Local Planning Authority planning application reference: APP/16/00898

Site: 23 South Street, Emsworth, PO10 7EG

Proposals: Alterations and additions for conversion from a dwelling to a boutique hotel including link to adjacent restaurant (C3 to C1) - Revised Application.

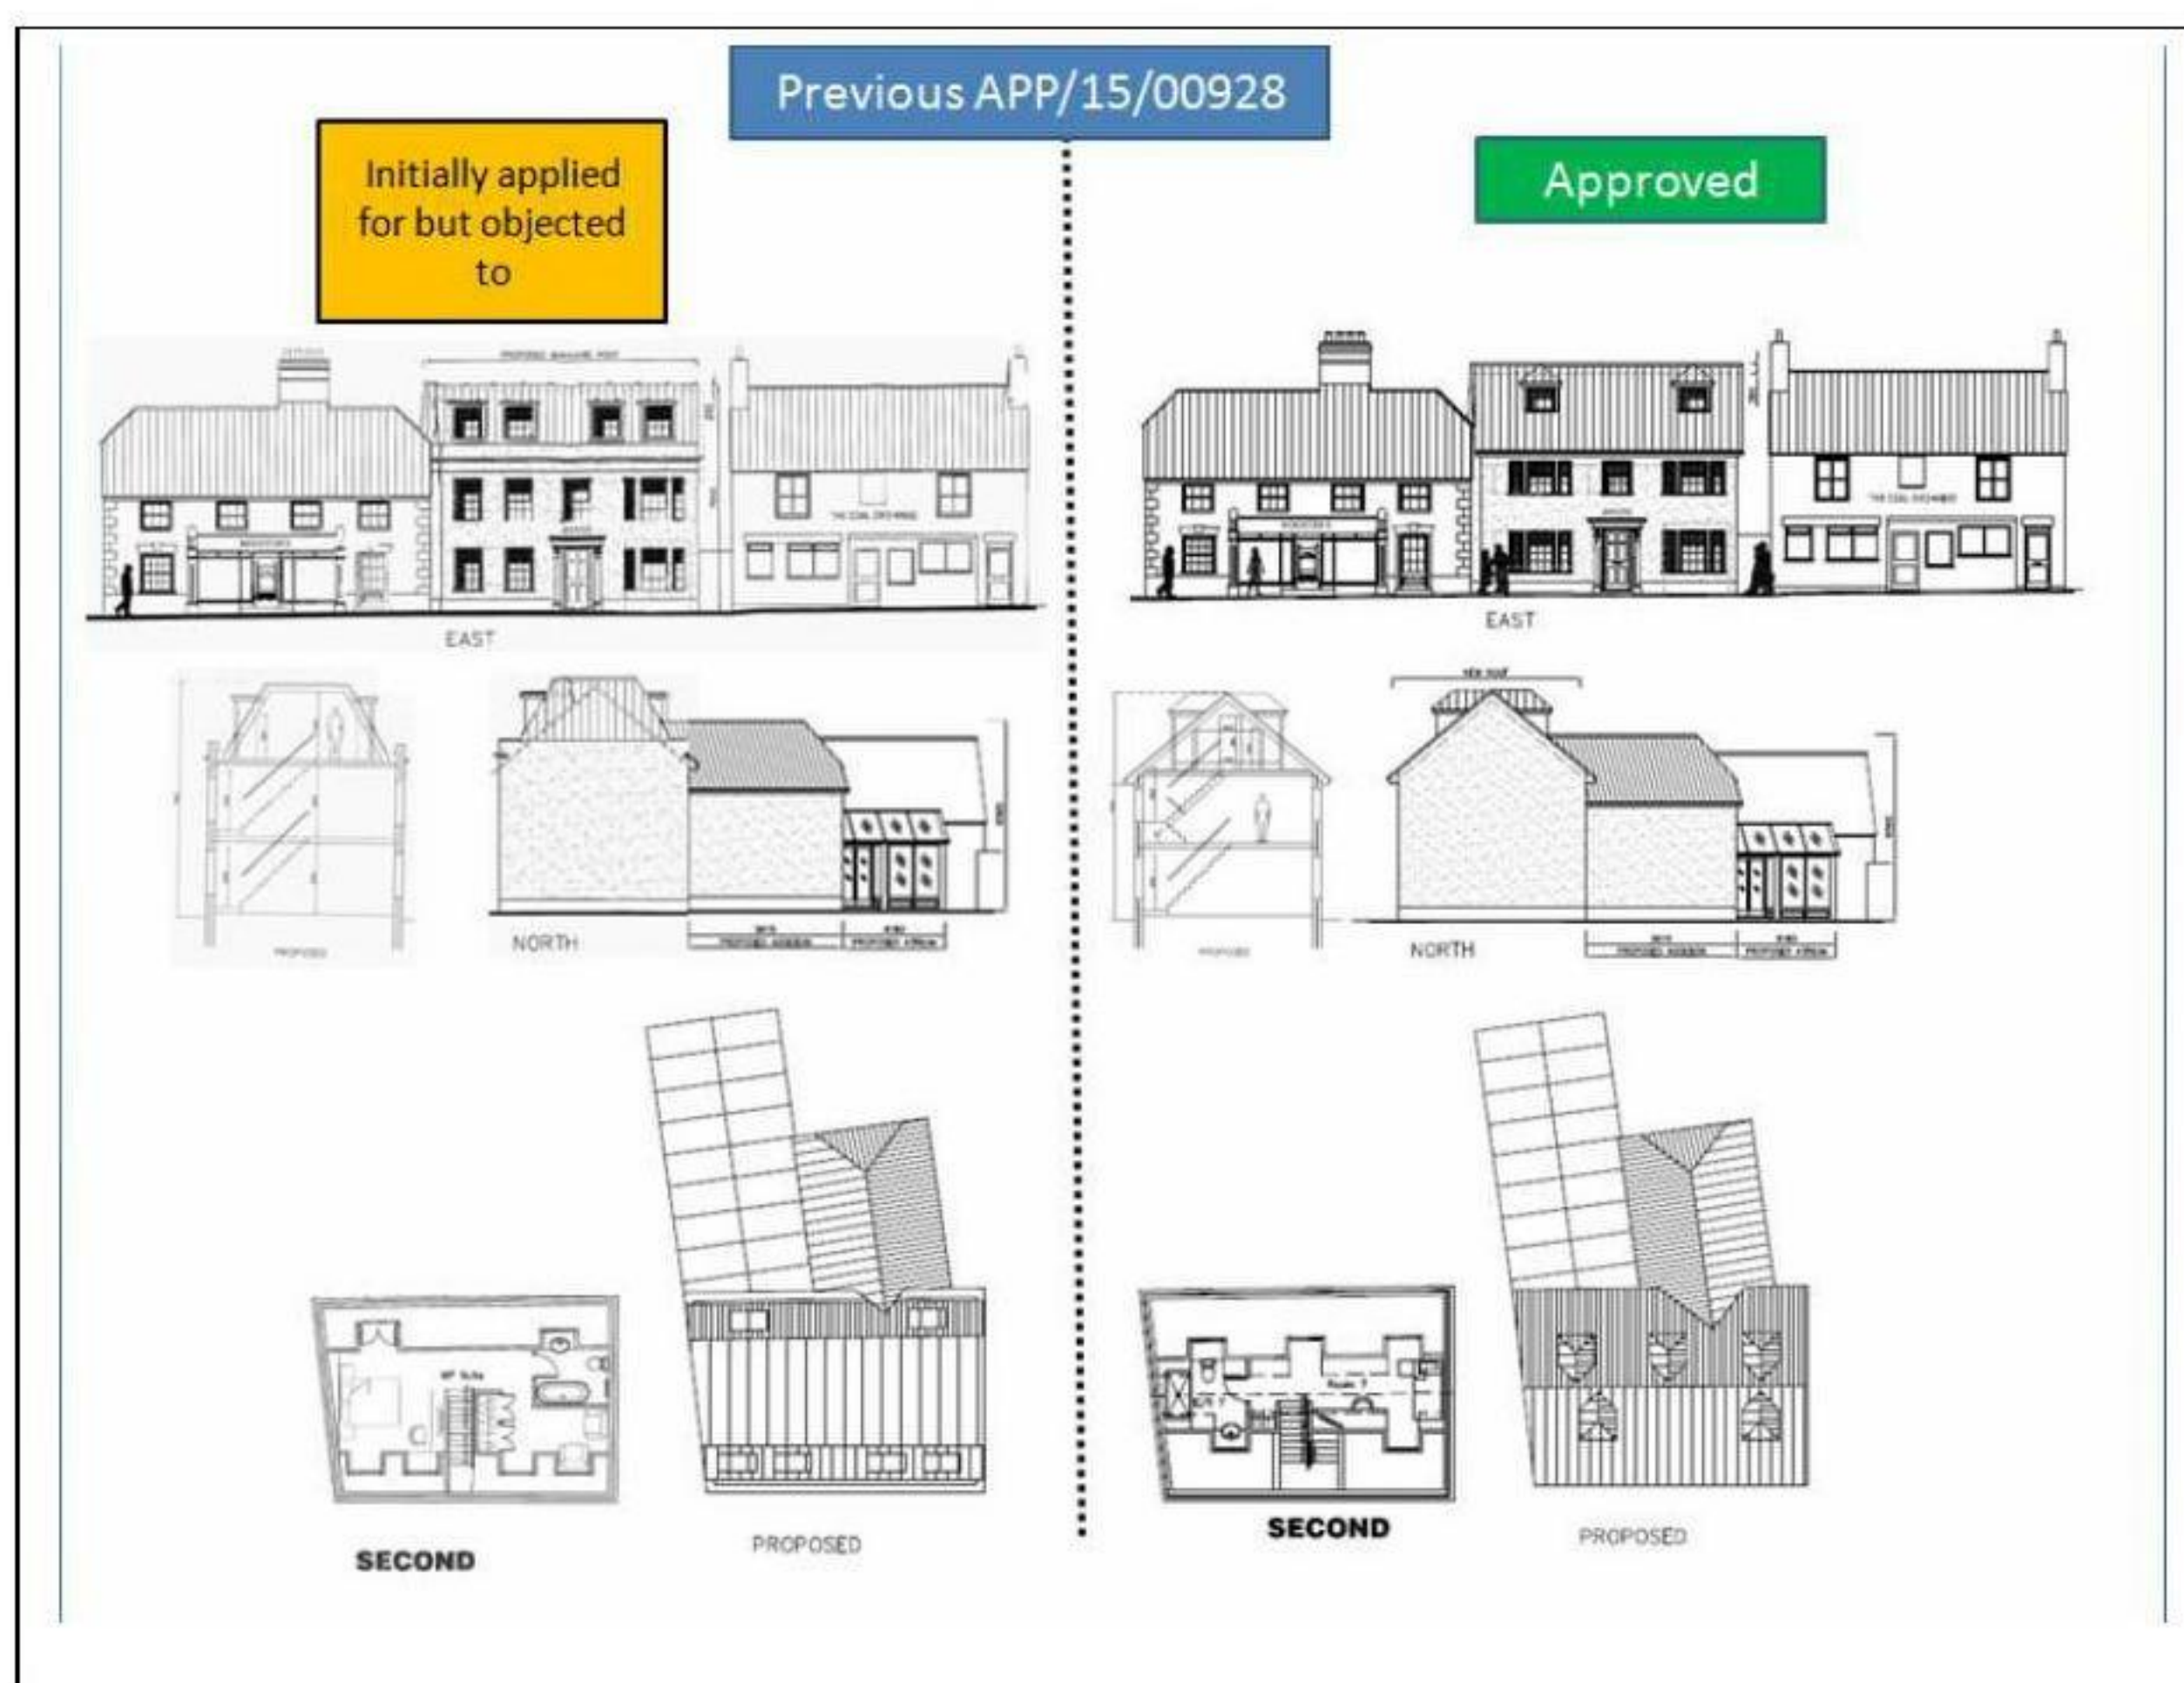
- Raising the roof ridge by 20.5 cm and altering its profile to a mansard with dormer windows front and back, with a parapet at the base of the roof;
- A barn-hipped roof two storey rear extension; and,
- A single storey projection beyond that.

- 2.2 Images of the existing and proposed elevational treatment are shown above.
- 2.3 In terms of external materials, the applicant proposes finishing the walls in render and stone paint to match the surrounding properties. The client's intention is to finish the mansard and dormer windows in lead, which is an appropriate material for Georgian period style. The pitched roof rear extension would also be in render and stone paint, with a slate roof.

- 3.3 (Harm to character of the street),
- 3.5 (Not in scale with its neighbours),
- 3.7 (Discordant to consistent roof line of its neighbours),
- 3.8 (Number of dormer windows considered disproportionate to roof surface, given the character of other dormer windows in the immediate surrounds),
- 3.9 (Loss of chimney which adds character to the roofscape),
- 3.10/3.11 (No consideration given to salvaging and re-use of existing plain tiles), and
- 3.22 (Overall erosion of the character of the Conservation Area).

- 4.3.1 Whilst it is appreciated that the applicant needs to increase headroom to create the 'loft' guest bedroom, altering the pitch to increase the roof height to be marginally higher than the ridge level of the Coal Exchange PH, should be the better option to achieve that. With fewer (say 2) and more discrete dormer windows to the front (as approved) and perhaps one dormer at the southern end of the roof surface slightly wider to the rear to give headroom at over that bedspace with associated en-suite handed, perhaps some revised plans could be negotiated.

That Havant Borough Council be informed that Chichester Harbour Conservancy lodges a holding objection to the application, as it considers the mansard roof profile, by reason of its added height and design, would appear alien within a run of conventional pitched roofs. As such, the development would not enhance the natural beauty of the Chichester Harbour AONB, nor preserve or enhance the character of the Emsworth Conservation Area. An alternative design should be negotiated.
